SIMON GENERAL COMMENTS:

SIMON FLOOR PLAN COMMENTS:

EssilorLuxottica Project Number 101228

1 ENLARGED STOREFRONT PLAN
 SCALE: 1/2" = 1'-0"

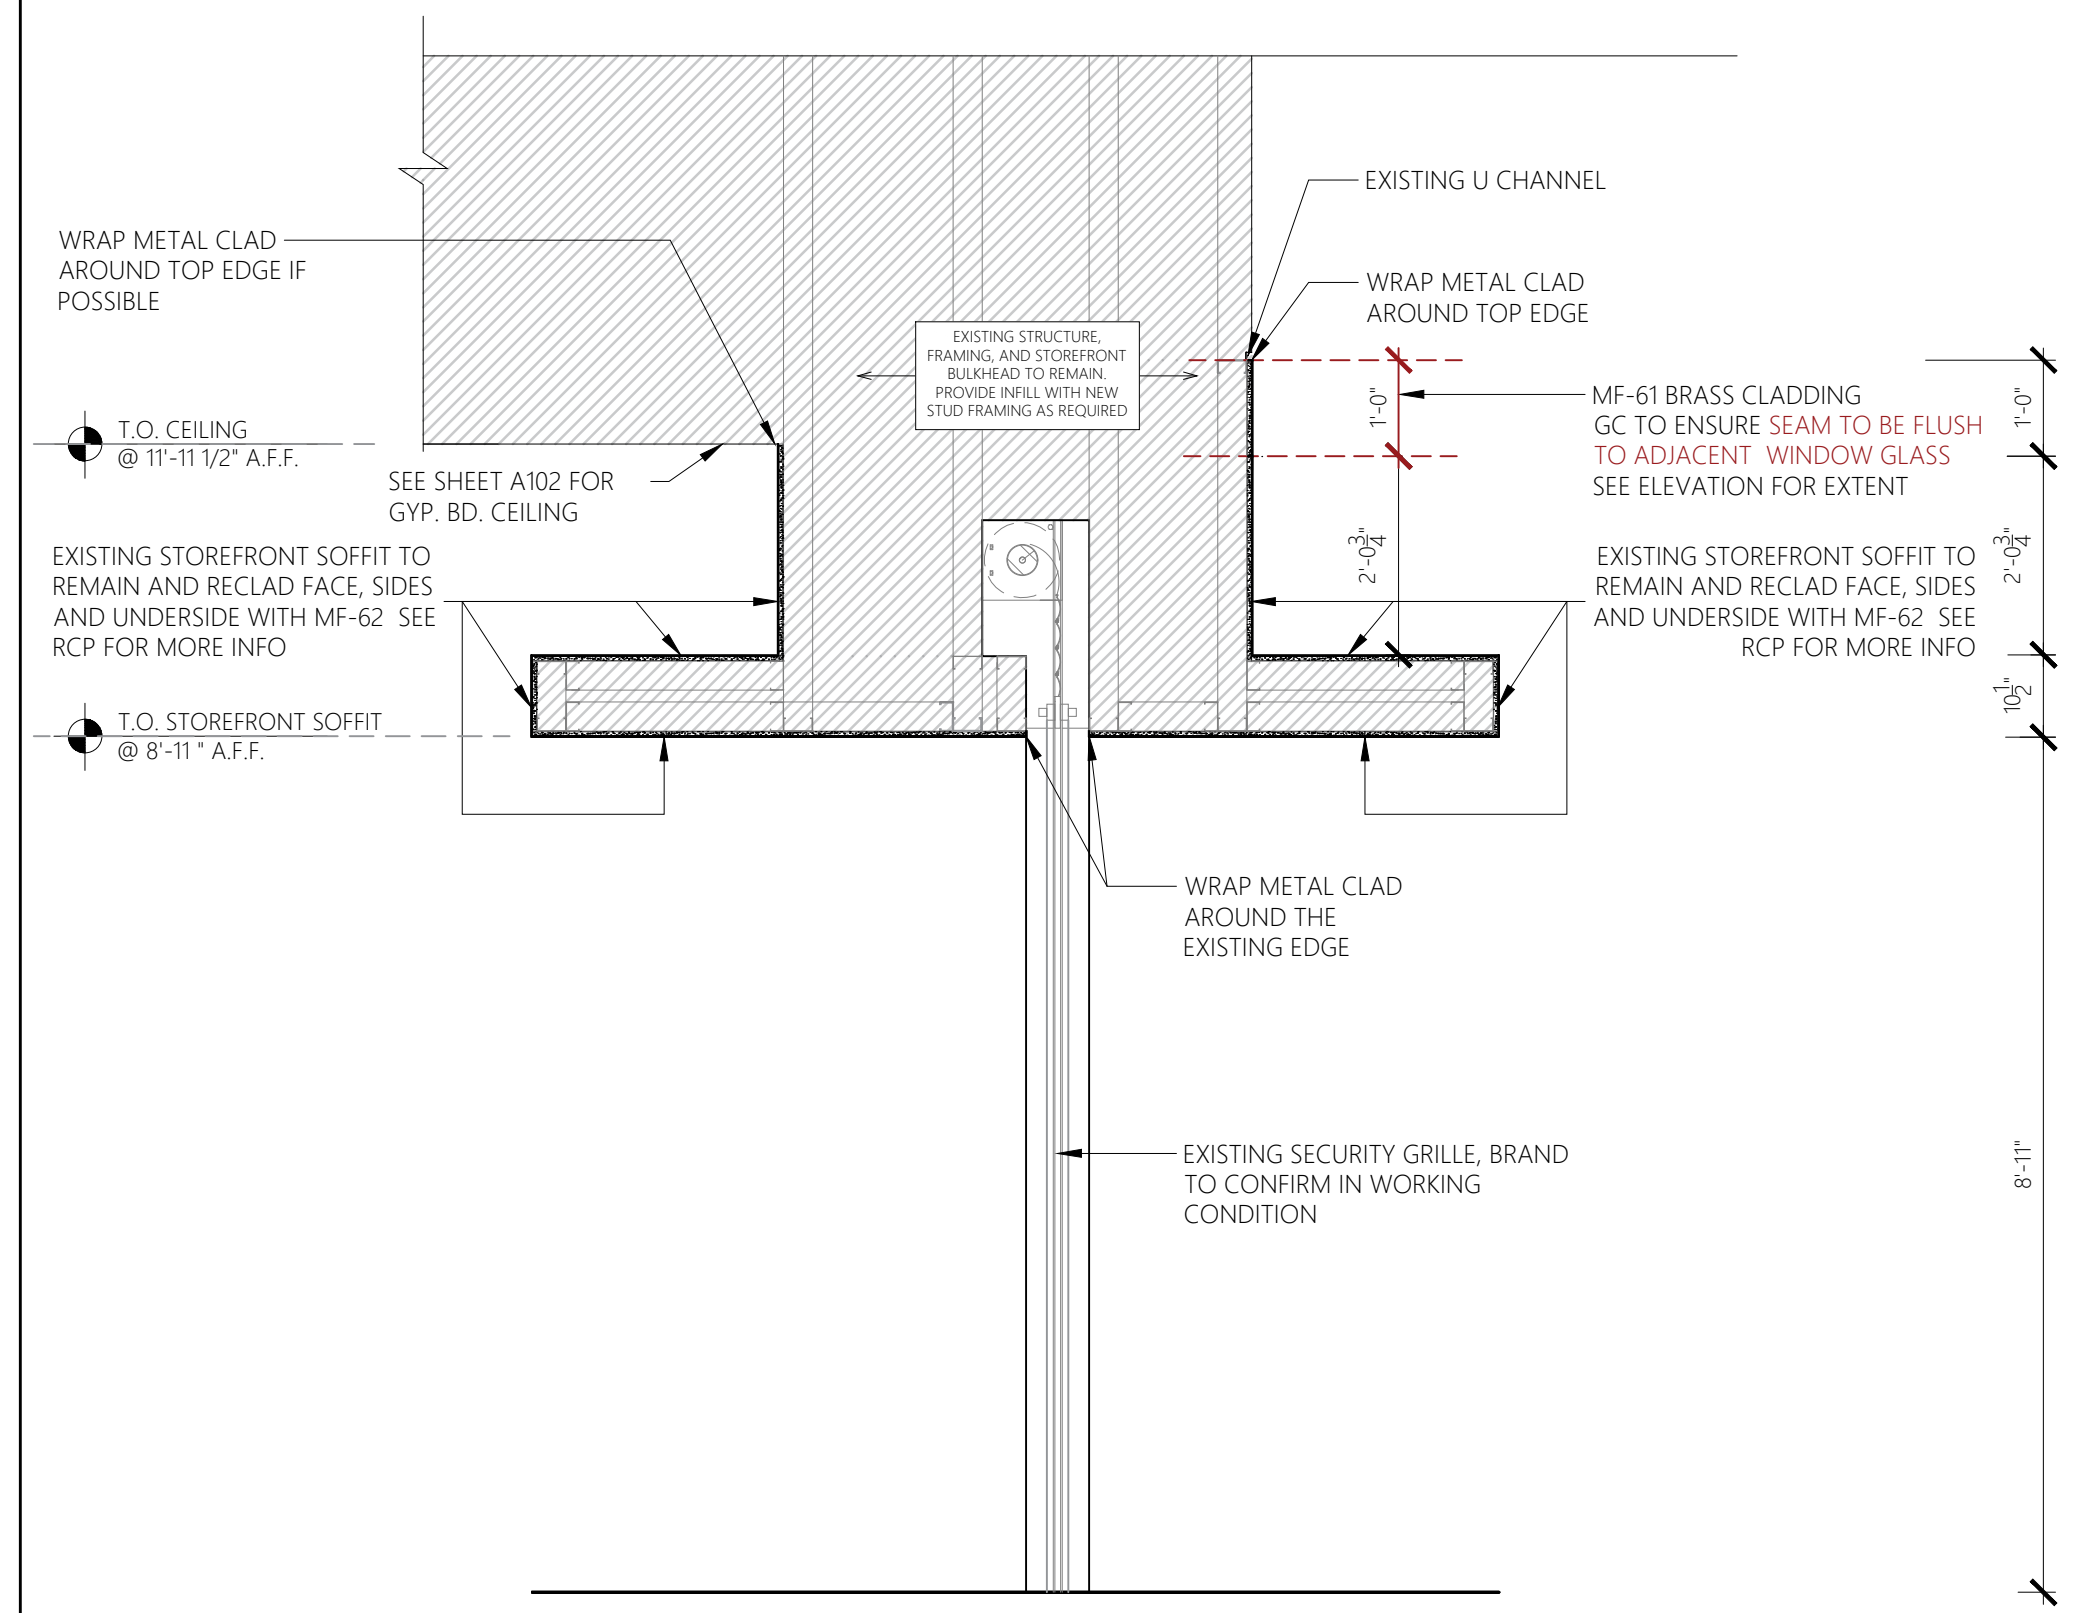
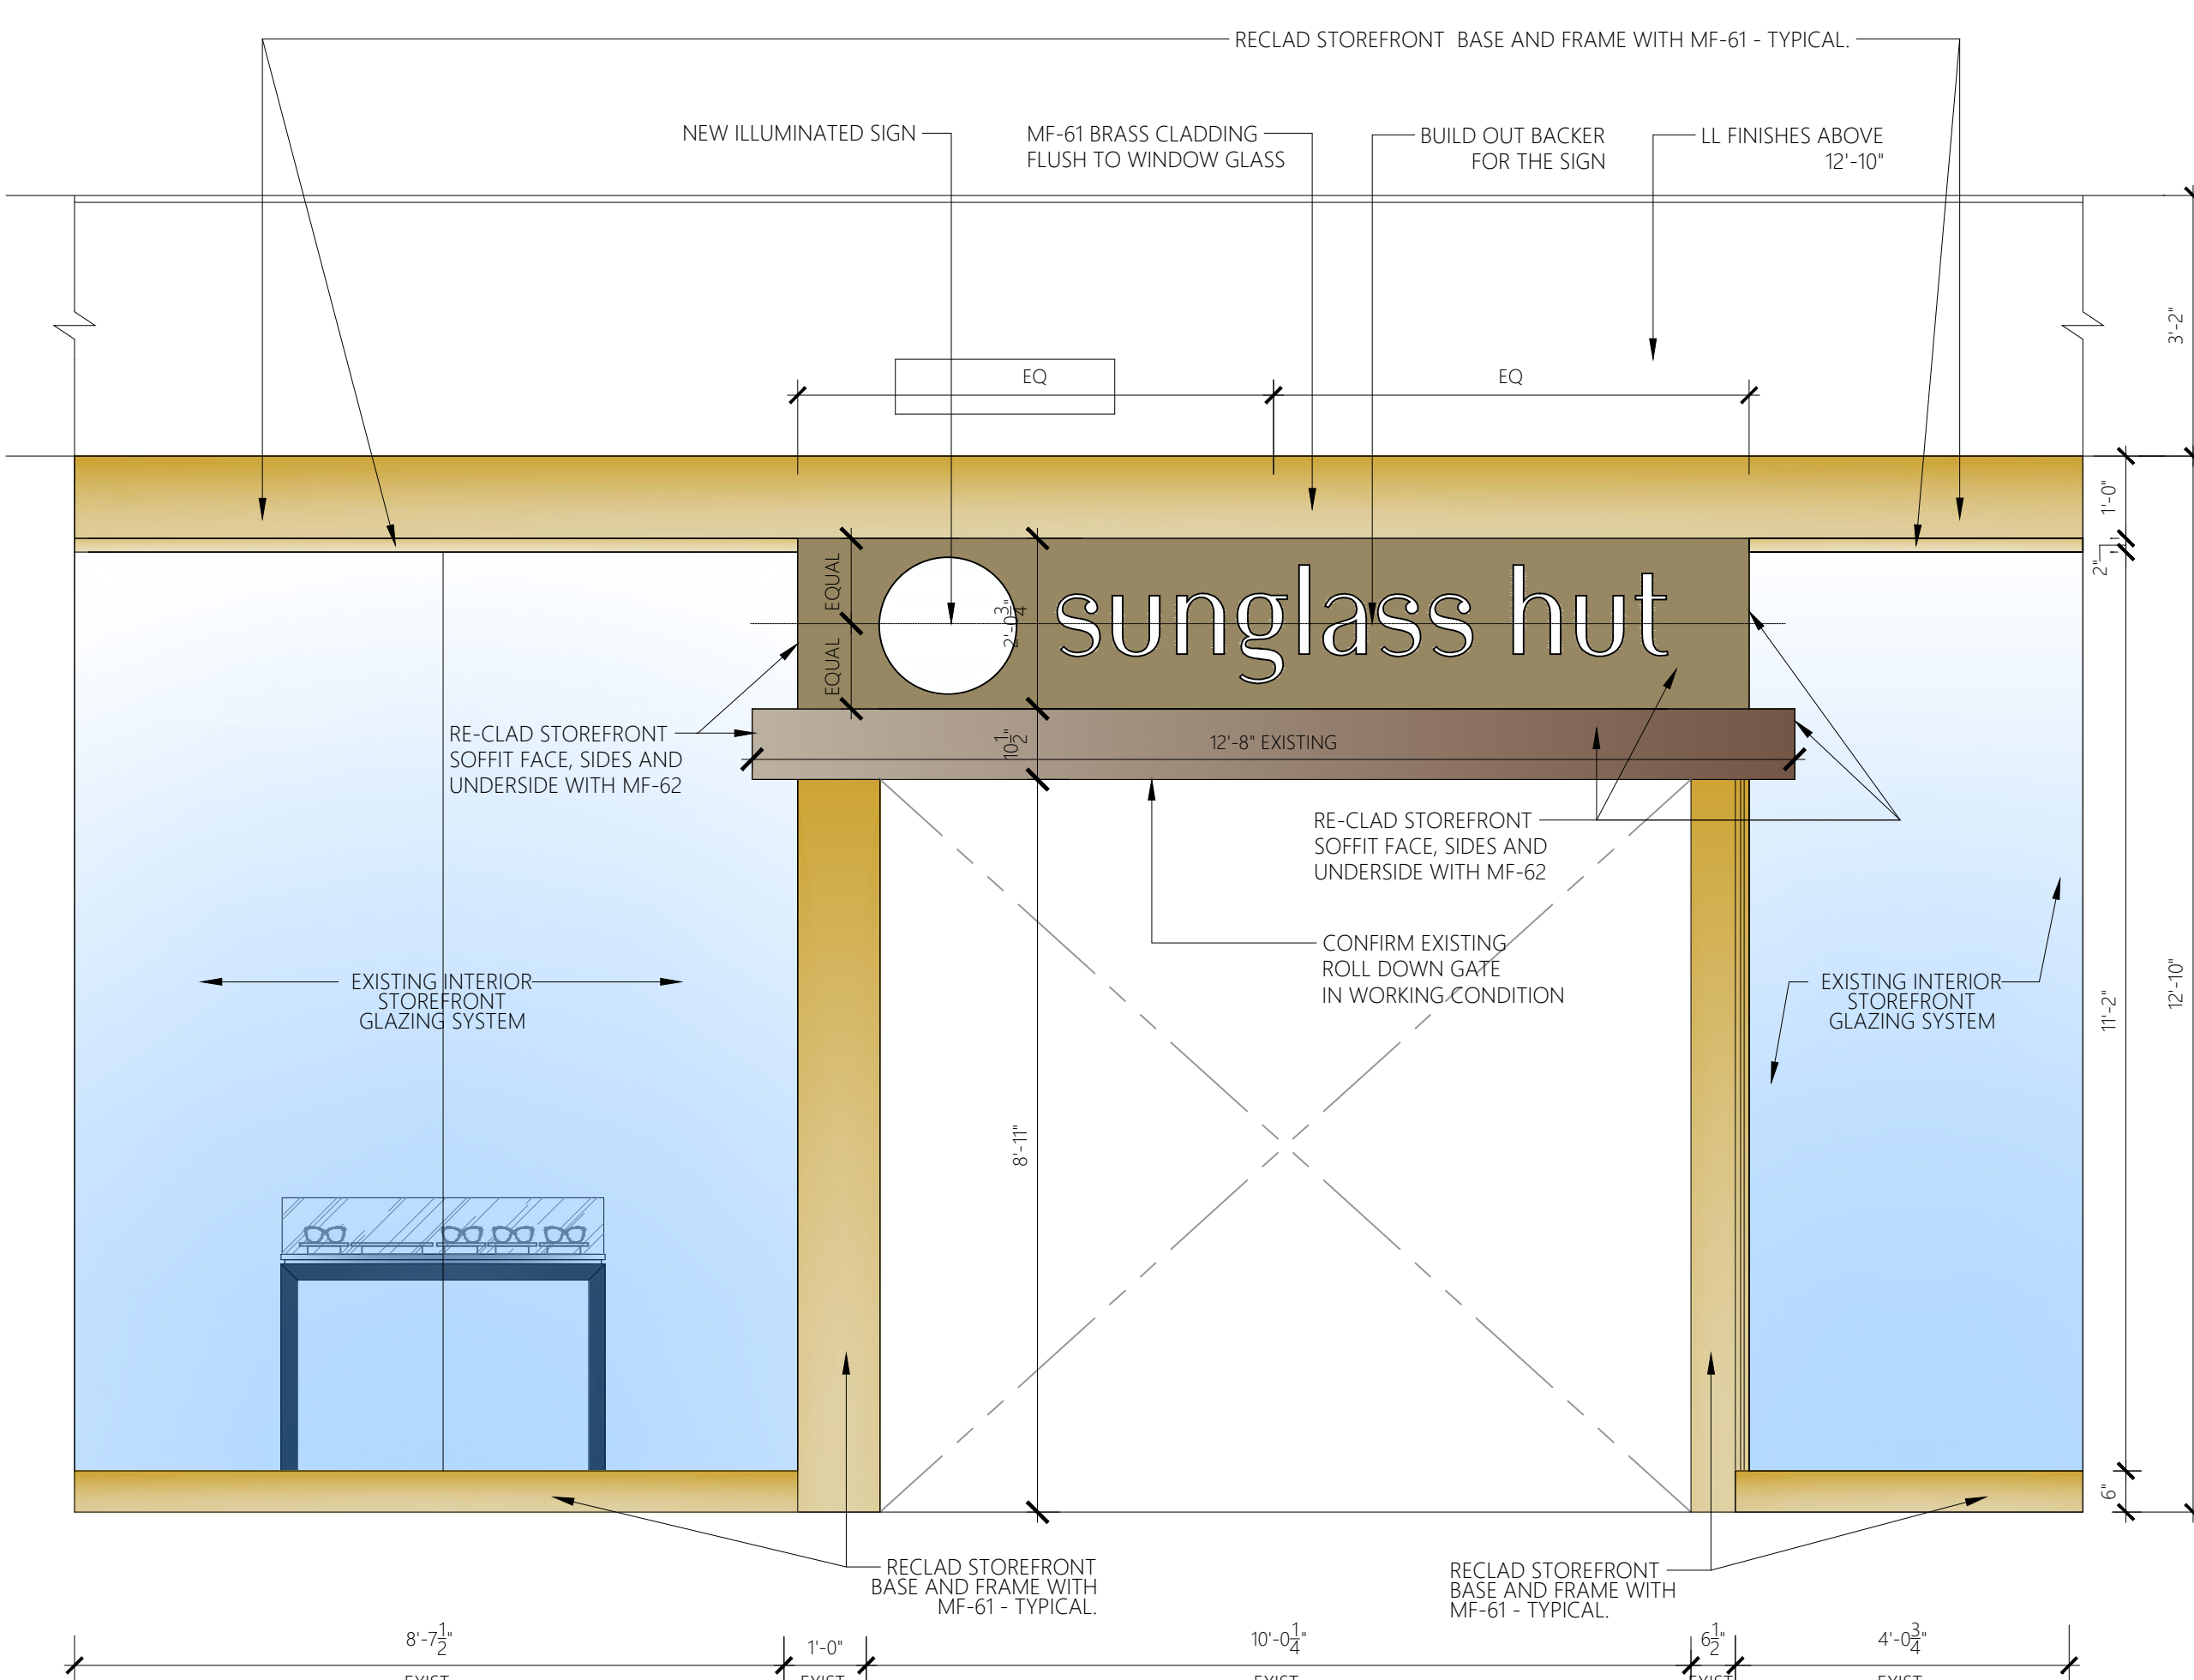
LL COMMENT (N/D): STOREFRONT SIGNAGE:
 TENANT TO INSTALL NEW STOREFRONT SIGNAGE TO MEET SIGN CRITERIA.
 TENANT RESPONSIBLE FOR PATCHING / REPAIRING / REFINISHING EXTERIOR FAÇADE FROM PREVIOUS TENANT SIGNAGE REMOVAL. PRIOR TO NEW SIGNAGE INSTALLATION, THE OPERATIONS DIRECTOR MUST APPROVE SAID REPAIRS.
 STOREFRONT SIGNAGE, STOREFRONT ENTRY LIGHTS, SHOW WINDOW LIGHTS AND SHOW WINDOW RECEPTACLES TO BE ON 24-HOUR / 7-DAYS A WEEK TIME CLOCK.
 NOTE: GC TO PROVIDE ADEQUATE BLOCKING AT SIGN LOCATIONS.
